CITY PROJECT NO. --	GRADING PLAN RUM RIVER RETREAT SUNDANCE WOODS, LLC	FILE NO. 19214-020
RAMSEY, MINNESOTA		11 30

1.11 - GP - RRR.pdf V4 - Changemark Notes (1 Note)

PRELIMINARY STORM PLAN
RUM RIVER RETREAT
SUNDANCE WOODS, LLC

PRELIMINARY STREET PLAN
RUM RIVER RETREAT
SUNDANCE WOODS, LLC

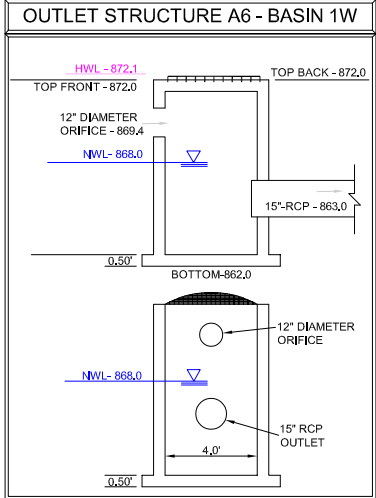
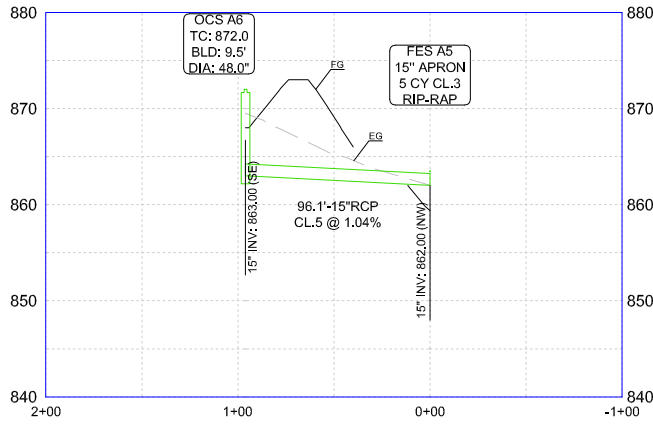
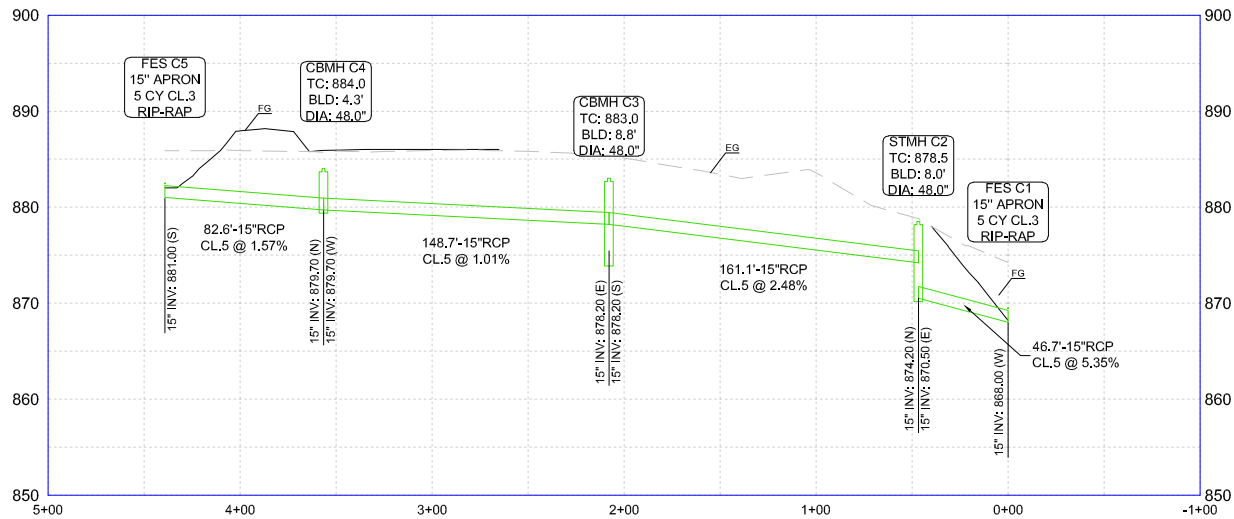
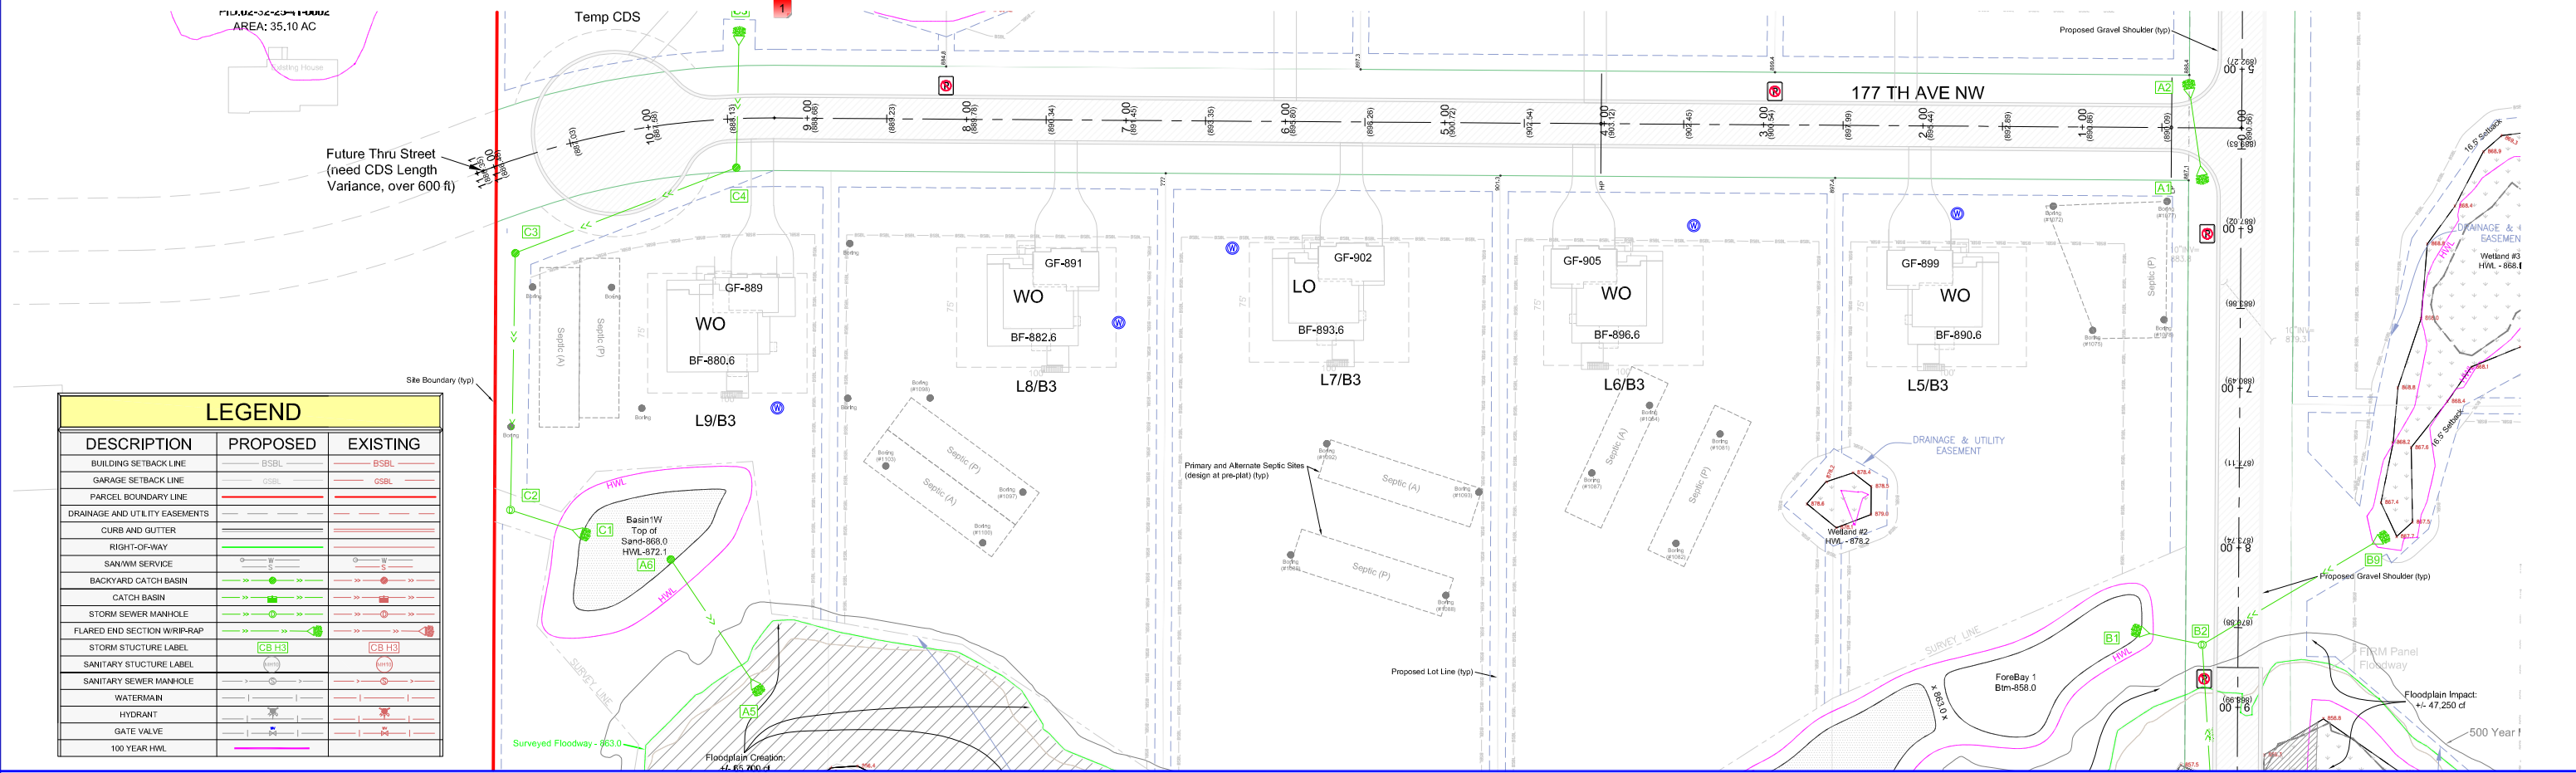
1 - WCA Permitting

Highlighting the LRRWMO comment on a WCA permit application being needed for specifically
for Wetland fill determinations

1.3 - STRT - RRR.pdf V4 - Changemark Notes (1 Note)

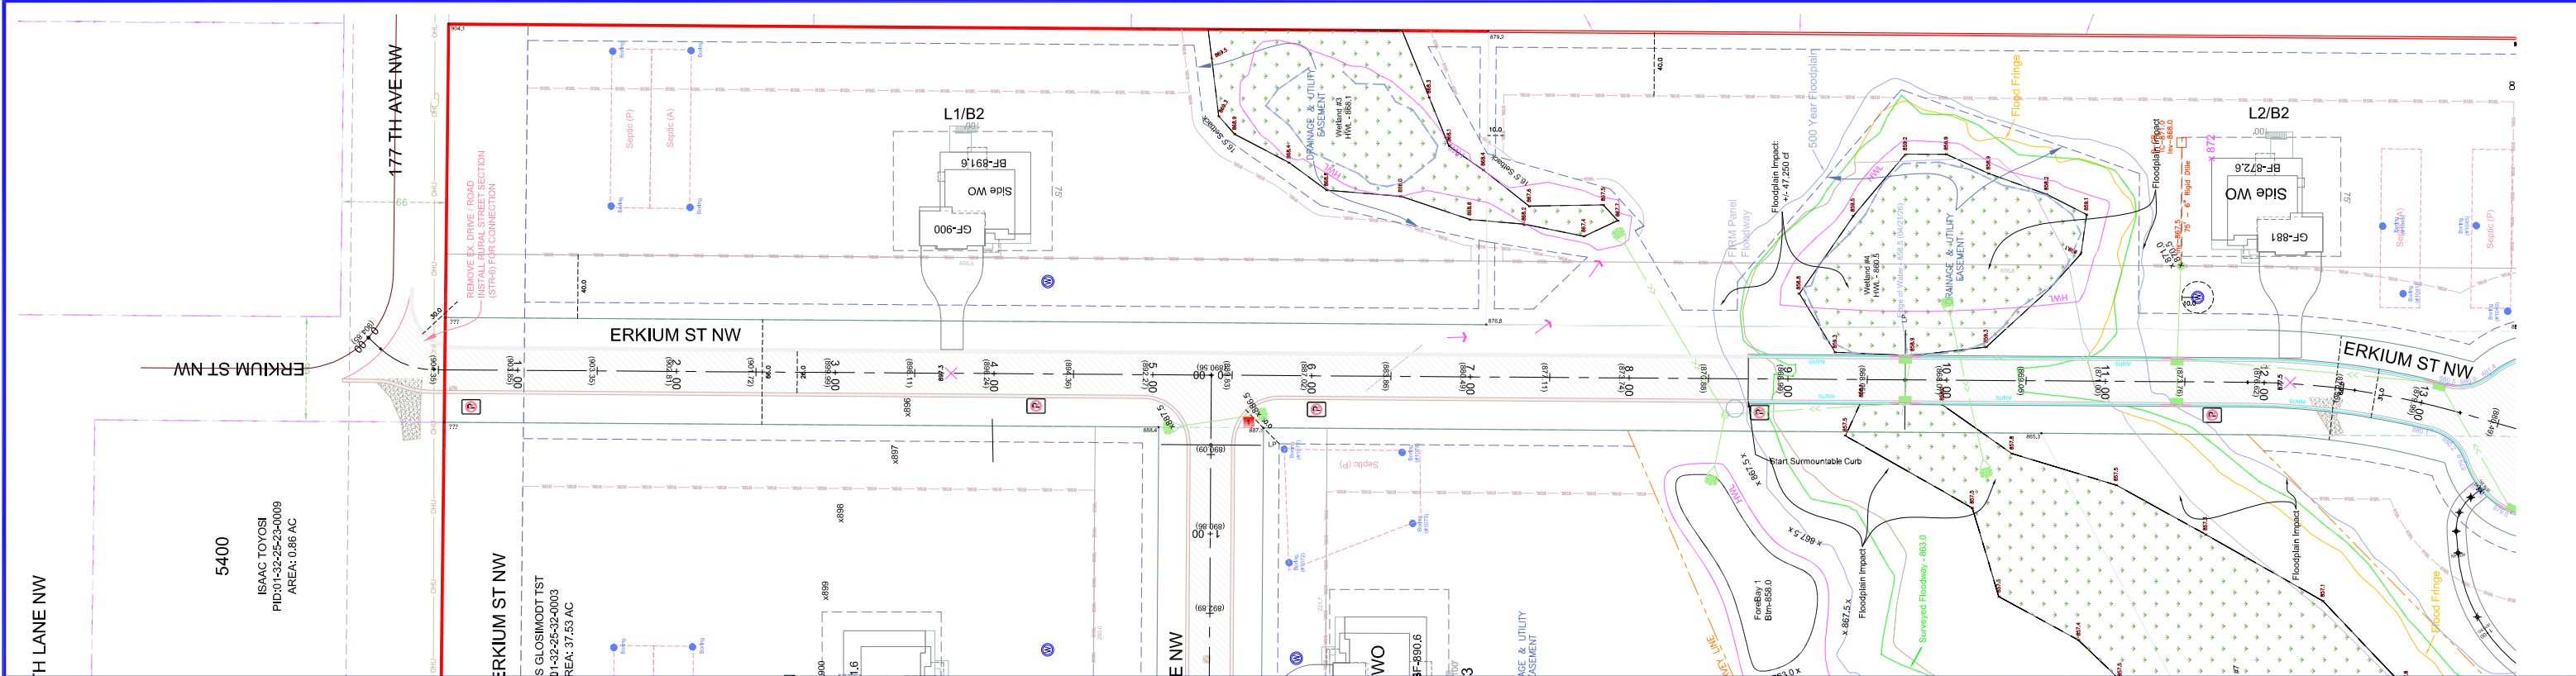
1 - Subbase Material

Has there been any geotechnical exploration performed where the roadway will go? I don't see it in the provided documents. Most of this property appears to be well drained sand; though there are some areas that may require soil correction, likely adjacent to the existing wetlands.
